REQUEST

Current Zoning: NS PED (neighborhood services, pedestrian overlay)
 Proposed Zoning: MUDD(O) PED (mixed use development, optional, pedestrian overlay)

Approximately 1 acre located on the west side of the intersection of East Boulevard and Scott Avenue, east of Kenilworth Avenue.

SUMMARY OF PETITION

• Proposed Request Details

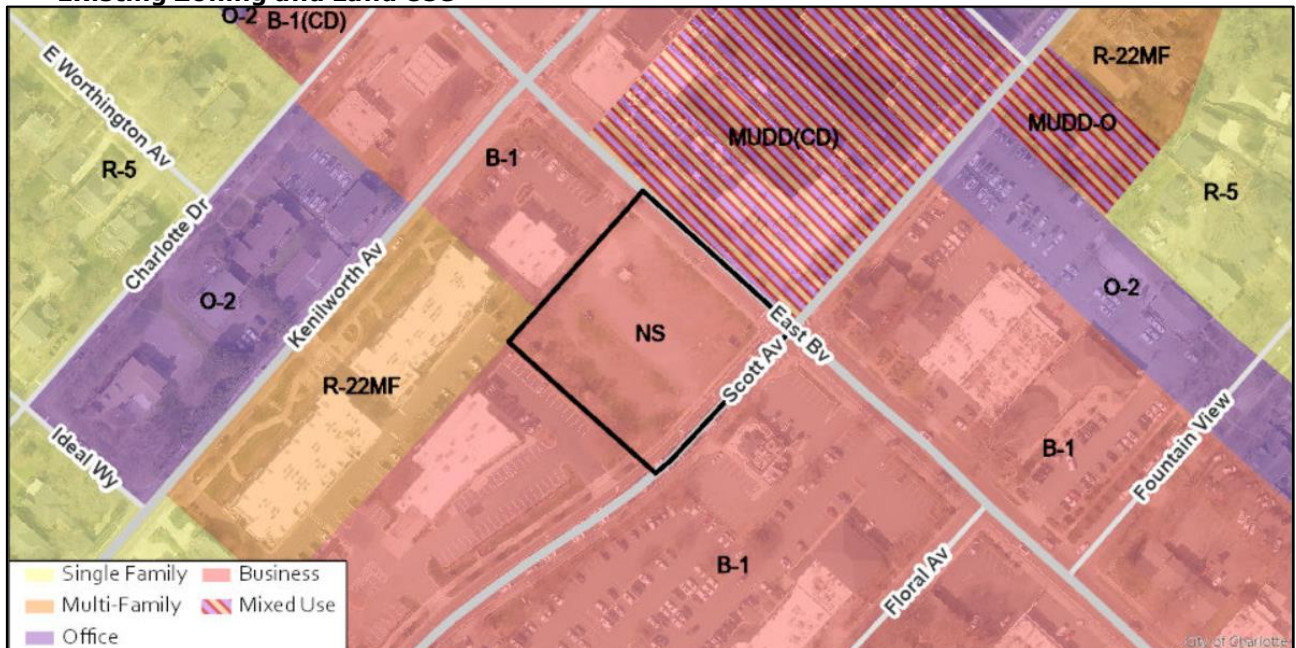
- Requests the following optional provision:
 - The ability to construct an overhead encroachment into the streetscape area along East Boulevard in order to accommodate a cantilevered building design starting a minimum of ~~16~~ 26 feet above the sidewalk. The Potential Building Overhang shall be a maximum of ~~8~~ 11 feet beyond the base level building footprint. For the sake of clarity, this encroachment area shall not be permitted at the building's base level.

- Requests a deviation from the adopted streetscape along the Site's frontage of East Boulevard as reflected in the Rezoning Plan.
 - Allow balconies to encroach up to 8 feet into the setbacks from all adjacent streets. Balconies shall maintain a minimum vertical clearance of 12 feet above grade.

- Limits building height to 85 feet.
- Proposes the following transportation improvements:
 - Proposes entrance only access from East Boulevard and left in/left out access onto Scott Avenue.

- Provides streetscape improvements along the Site's frontage of Scott Avenue as depicted on the Rezoning Plan. The sidewalk will be extended to the base of the building along the Scott Avenue frontage where feasible based on architecture. Trees may be located in ~~planters or~~ grates along sidewalk ~~areas or in planting strips.~~

- Illustrates future conditions after completion of East Boulevard widening proposed by others. As an interim condition, the Petitioner shall work in coordination with Urban Design Planning Staff to develop a hardscape plan that includes wider sidewalks and a combination of planting strip and/or tree planters within the limits as illustrated on the Rezoning Plan. Trees may be located in planters or grates along sidewalk areas or in planting strips.
